Subject: FINAL ENVIRONMENTAL ASSESSMENT FOR THE
GAC TREATMENT FACILITY AT NAPILI WELL "A"
NAPILI, MAUI, HAWAII (TMK 4-3-01:06)

FINAL ENVIRONMENTAL ASSESSMENT
FOR THE
GAC TREATMENT FACILITY AT NAPILI WELL "A"
NAPILI, MAUI, HAWAII
(TMK: 4-3-01: 06)

Subject: **RESPONSE TO COMMENTS ON THE DRAFT ENVIRONMENTAL
ASSESSMENT FOR THE GAC TREATMENT FACILITY AT NAPILI
WELL "A"**
NAPILI, MAUI, HAWAII **TMK 4-3-02:006**

extremely efficient in removal of most volatile organic compounds (VOC).

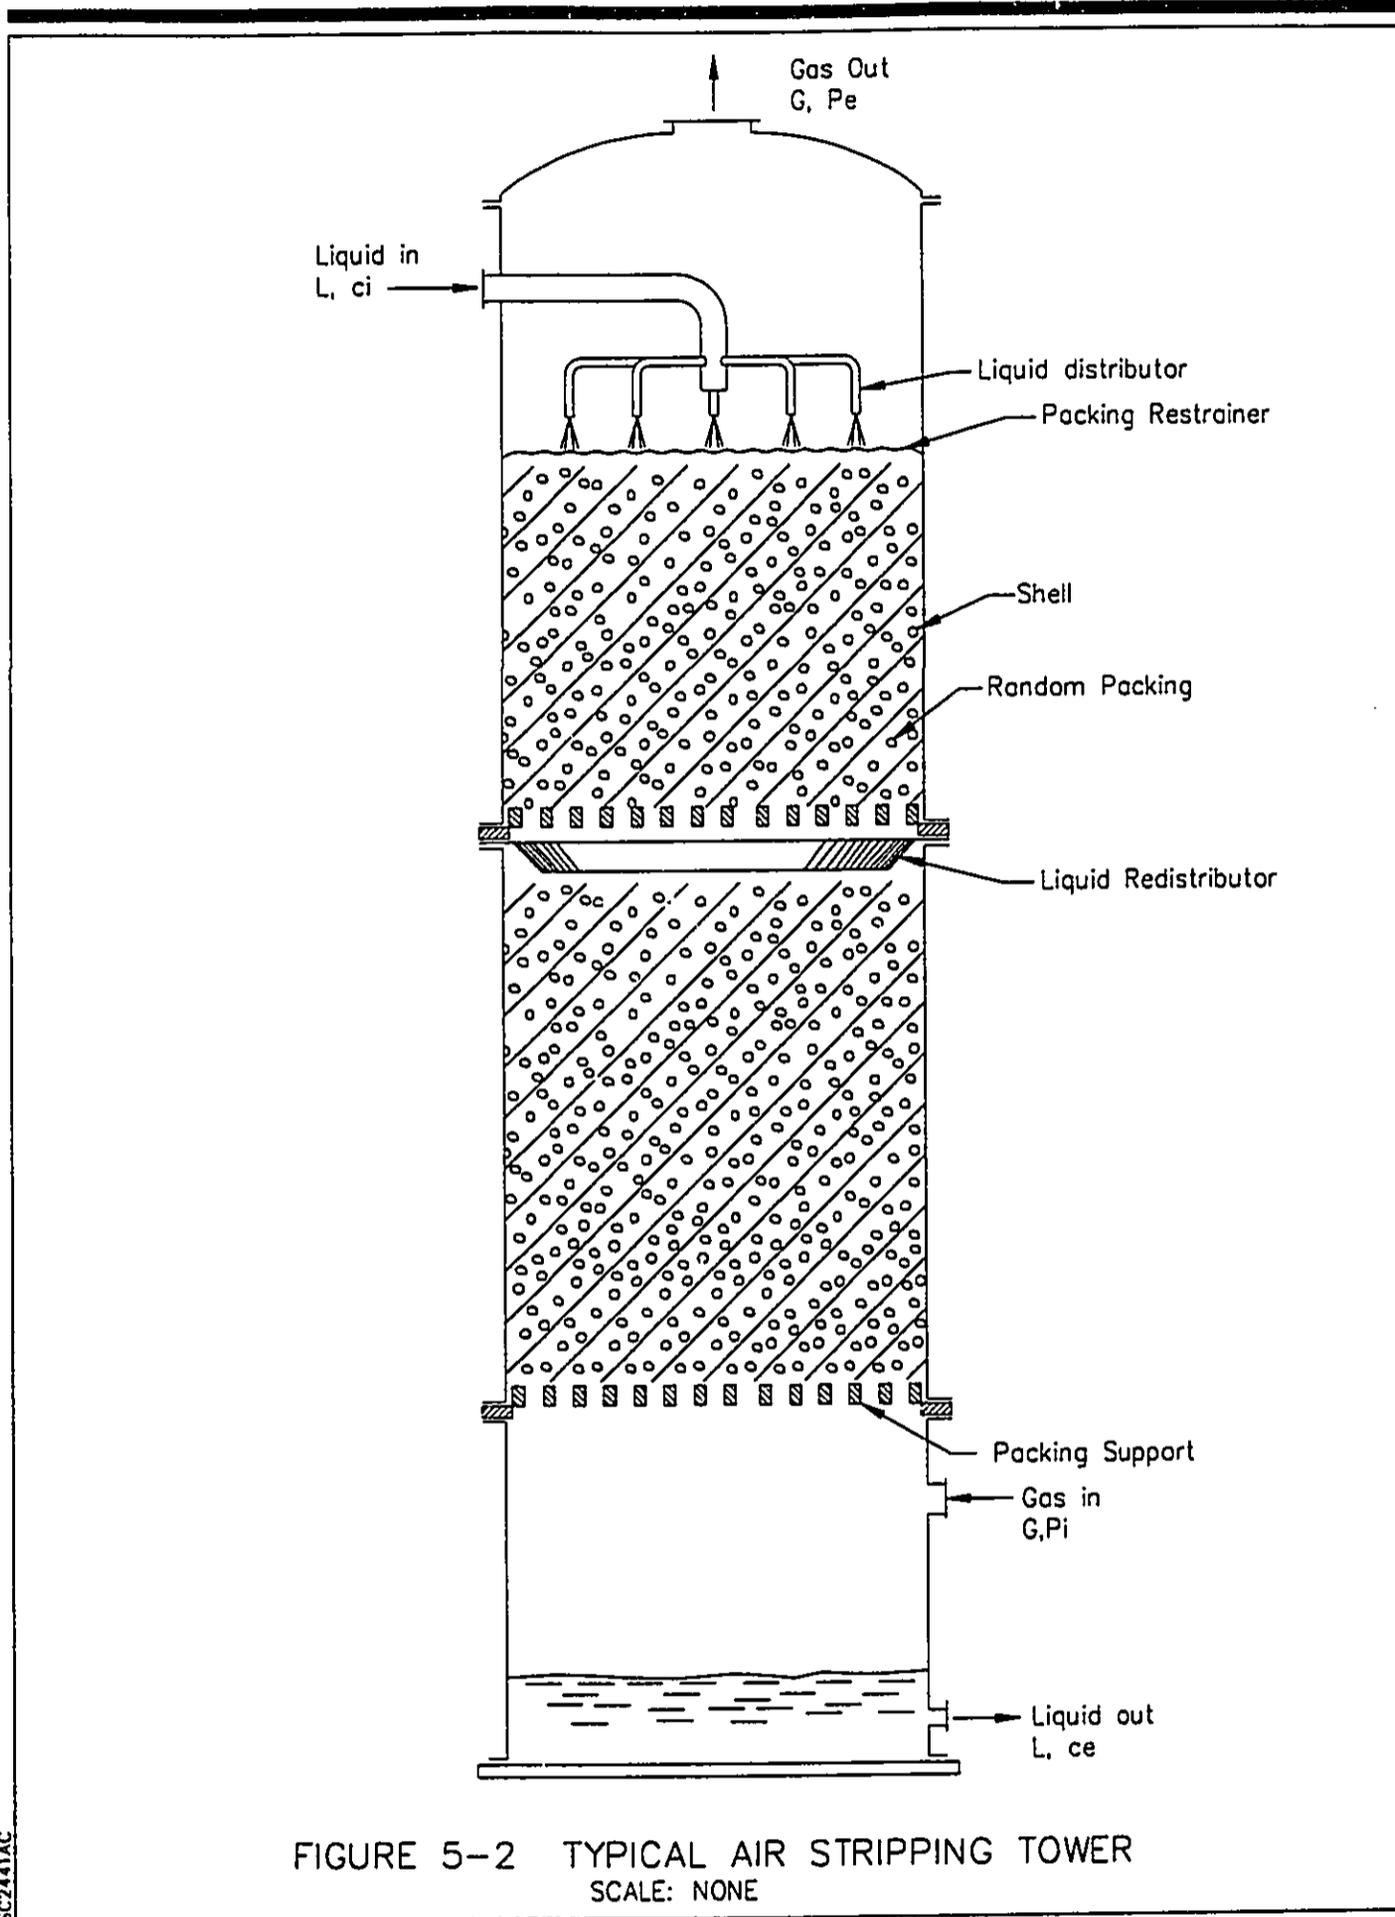
COMMENT: "The copy of the report we received has two instances where text is repeated on sequential pages (pp2-2/2-5, 2-8/2-9) and one where text is missing (the transition between pp 2-7/2-8). All the Figures should have a scale or other dimensioning to allow better understanding (i.e. Figures 2-1, 2-2, 2-3, 3-1, 3-2, 5-1 and 5-2).

RESPONSE: The text on pages 2-2/2-5, 2-8/2-9, and 2-7/2-8 has been corrected. Figures 2-1, 2-2, 2-3, 3-1, 3-2, 5-1 and 5-2 have been edited to include a scale.

FIGURE 5-3 NANOFILTRATION PROCESS

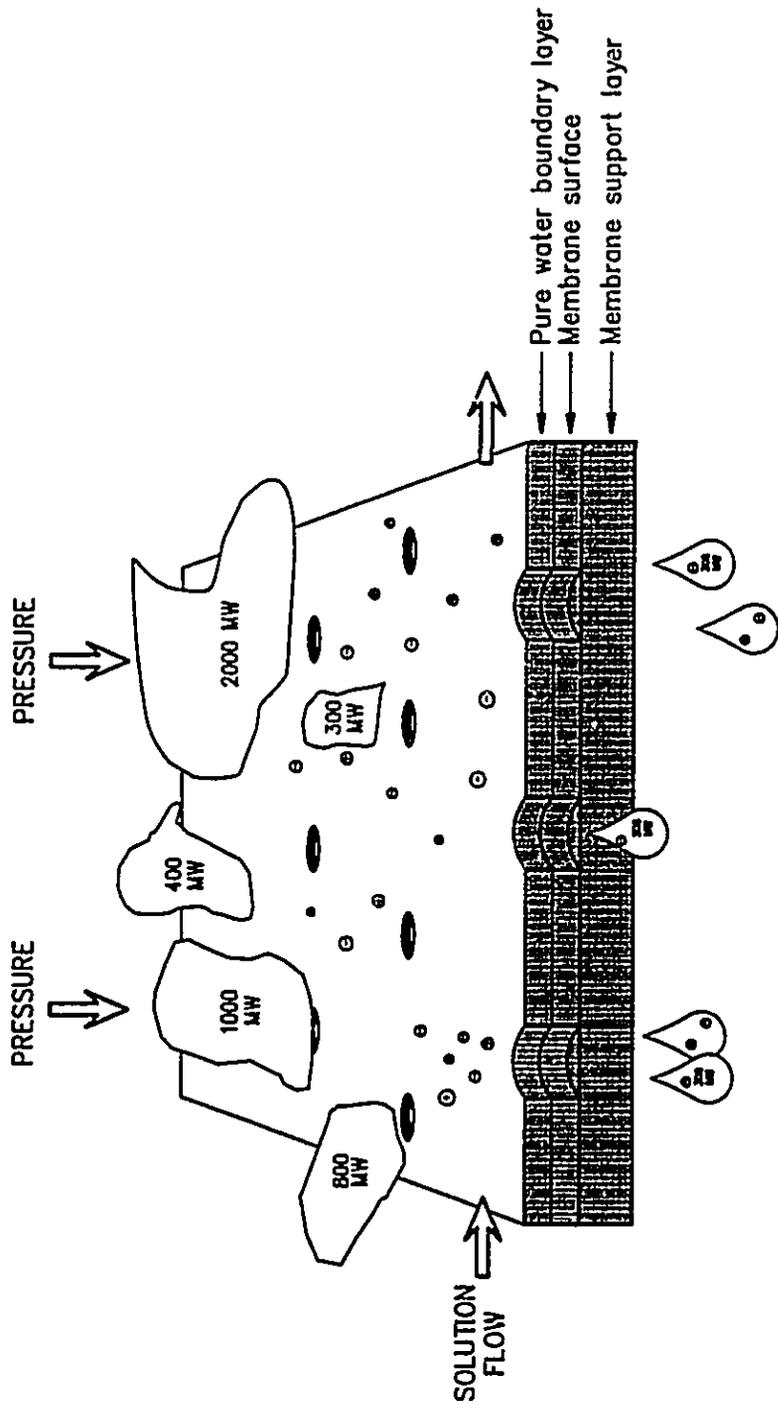
COMMENT: "Section 5.3.5. The report indicates that molecules larger than 1 nanometer (= 0.001 micrometer or 10 Angstrom) are rejected by nanofilters which is an oversimplification. In general nanofilter membranes and reverse osmosis (RO) membranes are rated based upon molecular weight cutoff (MWC) which does not preclude passage of that size or even larger molecules (it simply implies effective removal and smaller MW molecules will also be removed to some extent). Membrane processes are more complex and involve mechanisms other than single straining which

would preclude any particle larger than the nominal pore diameter. RO membranes usually have MWCs of about 100 and nanofilter membranes have MWCs of 200-50 (figure 5-3 shows MWC of 300). The MW of DBCP is 263.36. Previous work has been conducted using nanofiltration for removal of DBCP and other fumigants found in Mililani well water. There is a Masters of Civil Engineering Thesis dated 1995 available by D. Chaturvedula entitled 'Treatment of Mililani I well water by nanofiltration.' In that thesis, two nanofilter membranes were tested. The cellulose triacetate (CTA) membrane only achieved about 20% removal of DBCP. The thin film composite (TFC) membrane was able to achieve complete removal of approximately 20 ng/L of DBCP (detection limit unreported). The MWC's for each membrane tested were not reported but the TFC membrane was probably 'tighter' than the CTA unit and may have had a NWC of about 200."

RESPONSE: Section 5.3.5 has been edited to include your comment as follows:
"Membrane processes such as nanofiltration are often rated based on nominal pore size, or on the smallest size of contaminant that the membrane will effectively remove (also known as the molecular weight cut-off [MWC])..."
